PHILADELPHIA ELECTRIC COMPANY

SUBJECT: QA Program Description Changes for Peach Bottom Atomic Power Station,
Units 2 & 3

REFERENCE: Letter from T. T. Martin to S. L. Daltroff, dated 12/5/84

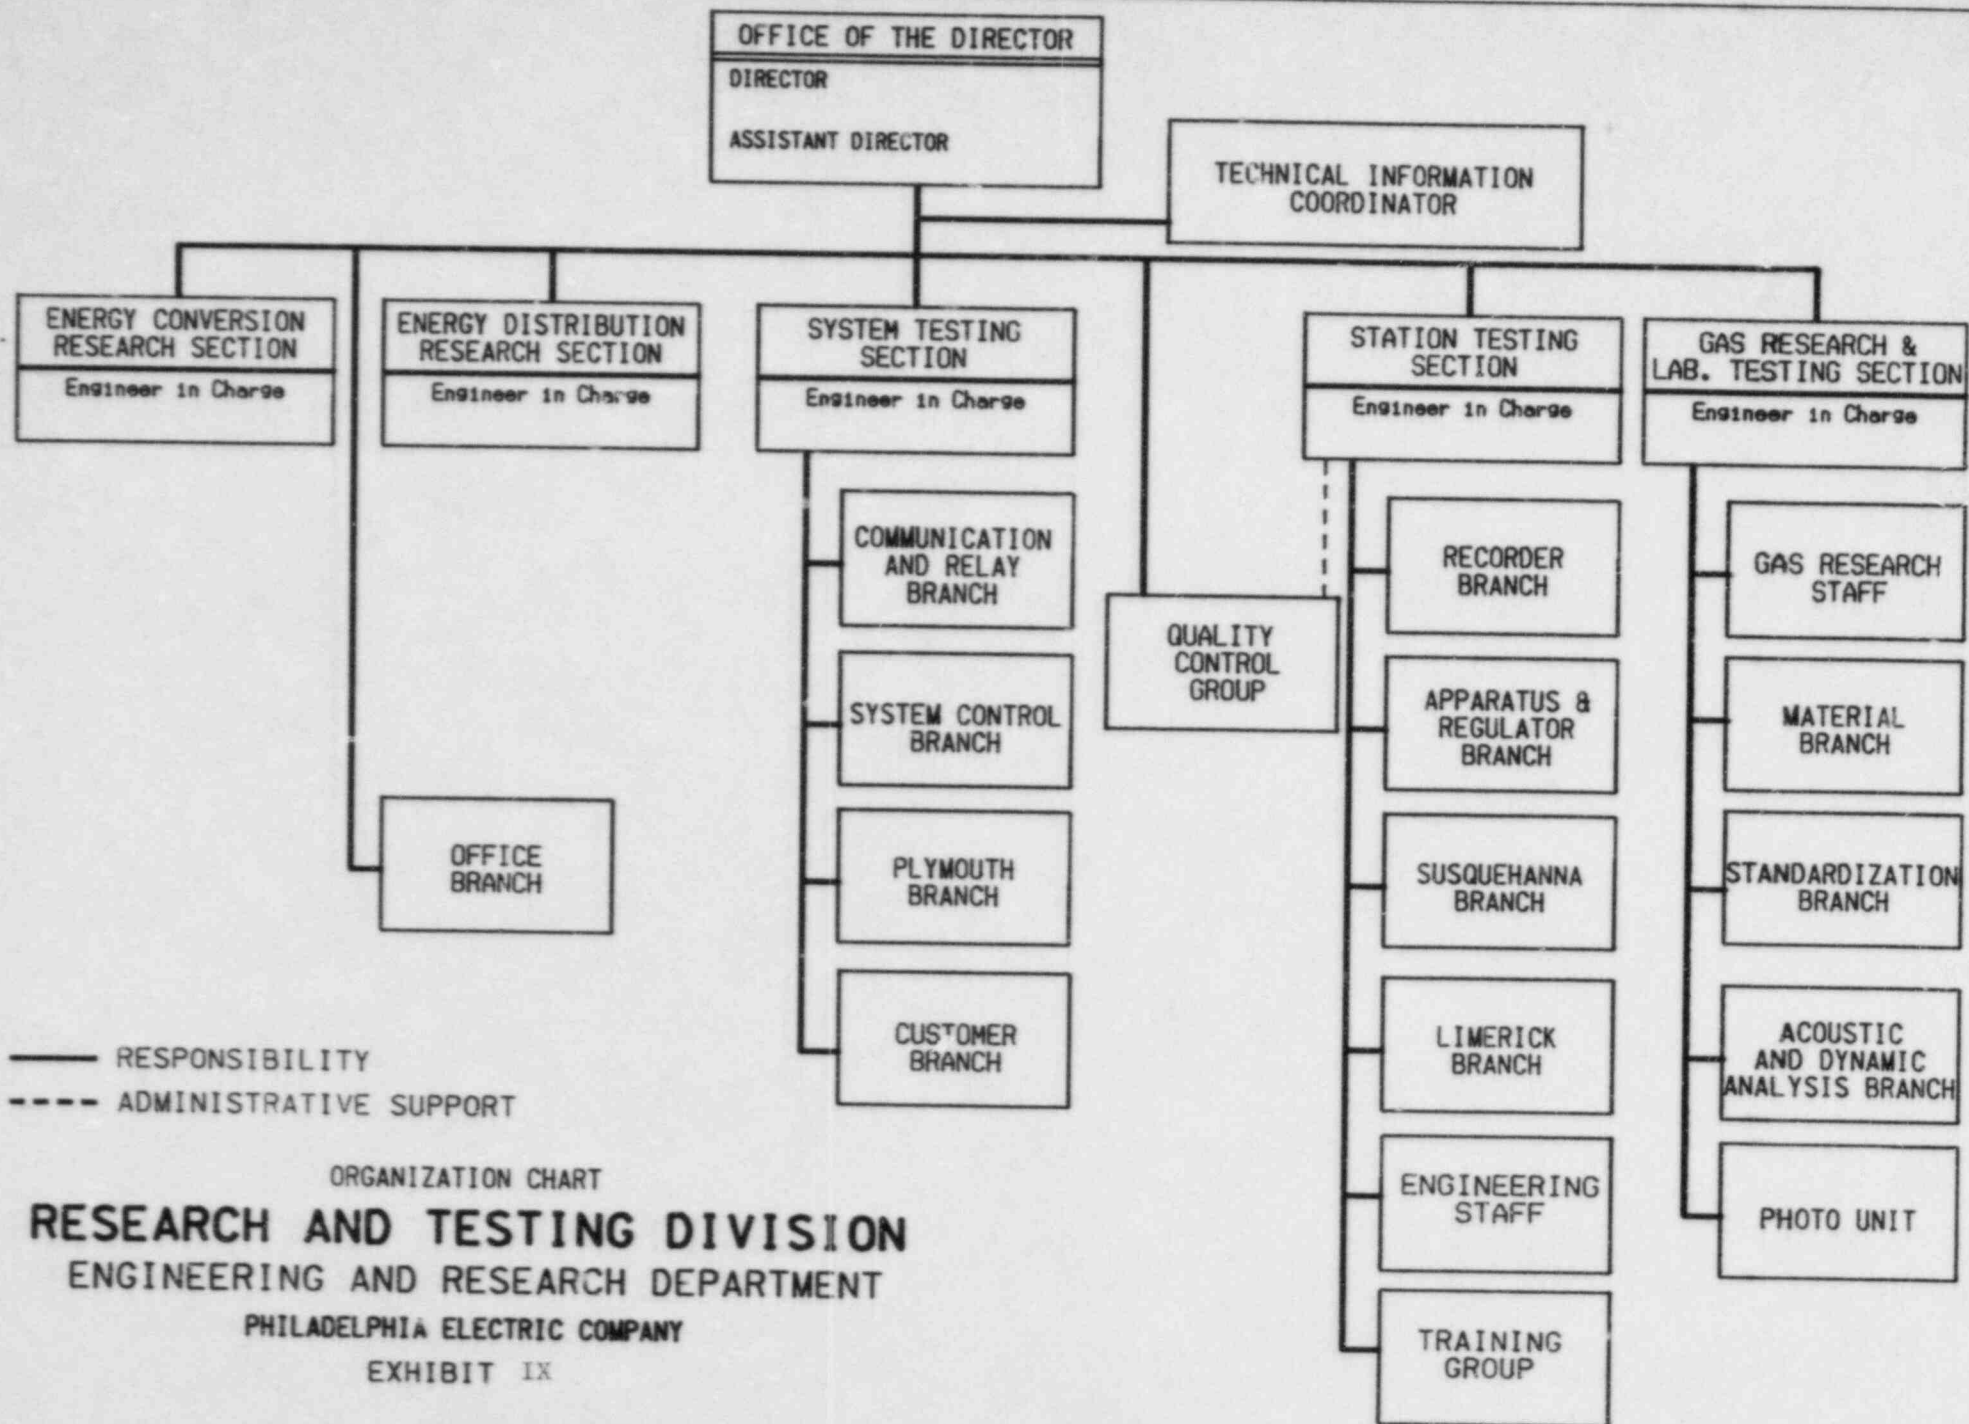
- 2) Concern: The Quality Control Group (Section 17.2.1.3.4.4) of the Research & Testing Division is not shown on an organization chart nor does Section 17.2.1.3.4.4 delineate where it reports.

Resolution: Section 17.2.1.3.4.4 has been revised to delineate where the Quality Control Group reports. In addition, an organization chart of the Research & Testing Division has been included as Exhibit IX.
